**SUNDRY NOTICES AND REPORTS ON WELLS**

**XTO Energy Inc. intends to plug and abandon this well per the attached procedure. Please see also attached current and proposed wellbore diagrams.**

## PLUG AND ABANDONMENT PROCEDURE

### Ute Indians A #38

## Proposed P&A

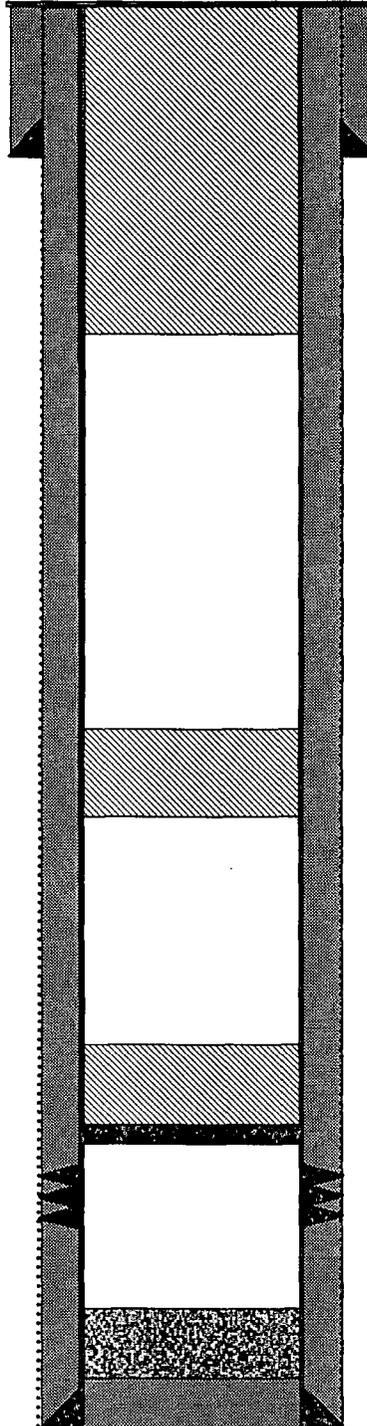
*\* Add a Morrison Plug from 2804'-2904'*
